Technical Service Information

ALLISON 1000/2000 SERIES

3RD OR 5TH GEAR STARTS

DTC P0705, P0706, P0708

Figure 1

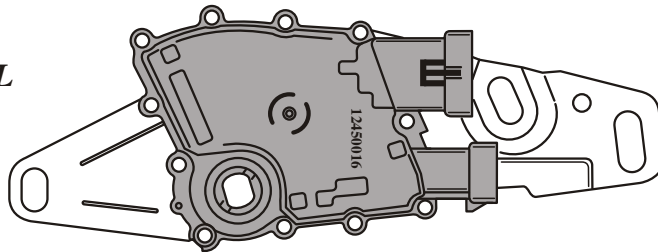
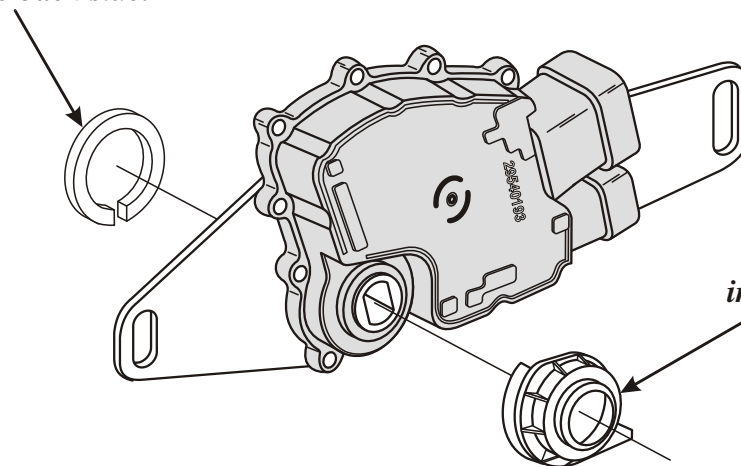
CAUSE: The cause may be, a defective Neutral Start Back-Up (NSBU) switch, created by weather intrusion. The NSBU switch is mounted on the exterior of the transmission and rotated by the manual shaft, as shown in Figure 1.

*Previous design level PNB
Switch is "Black" in color.*

*New PNB Switch has
seal glued to back side.*

CORRECTION: There is now available from OEM parts sources, a revised NSBU switch that has improved sealing capabilities to help prevent water intrusion, and is available under OEM part number 29540479. (See Figure 1) Since the original switch is the same part number as the 4L60-E switch, high ambient heat may have caused the sealing compound in the switch to melt and flow into the connectors, sealing the connectors to the switch. There is now available from OEM sources, service repair connectors for both the 7-way and the 4-way connectors under part numbers 15305887 and 15305925 (See Figure 3).

*New service package
includes cover for front
side of new switch.*

*New design level PNB Switch is "Tan" in color,
and is available under OEM part number 29540479.*

Figure 3

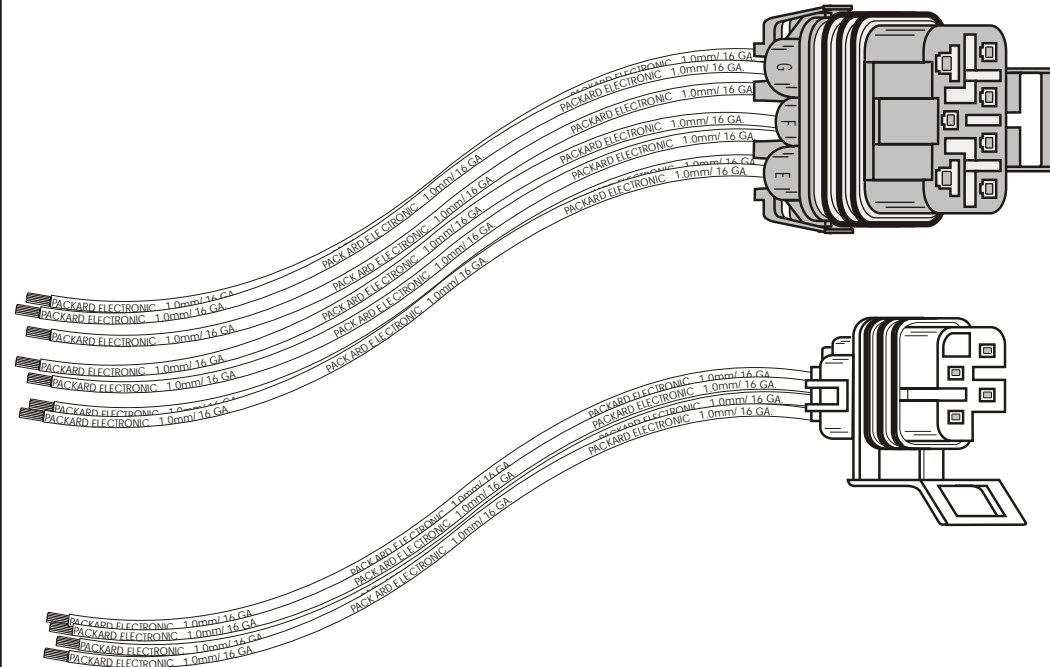
Note: The service connector pigtails use wires that are all the same color. Use the old connector as a pattern to ensure that the new wires are connected to the vehicle harness correctly. This switch is in a wet area, and it is *imperative* that the wires be soldered and heat-shrink tubing be used to insure water-tight connections. Refer to Figure 1 for the location of the Park/Neutral Position Switch. Refer to Figure 2 for a full wiring schematic of the Park/Neutral Position Switch circuit for diagnostic purposes.
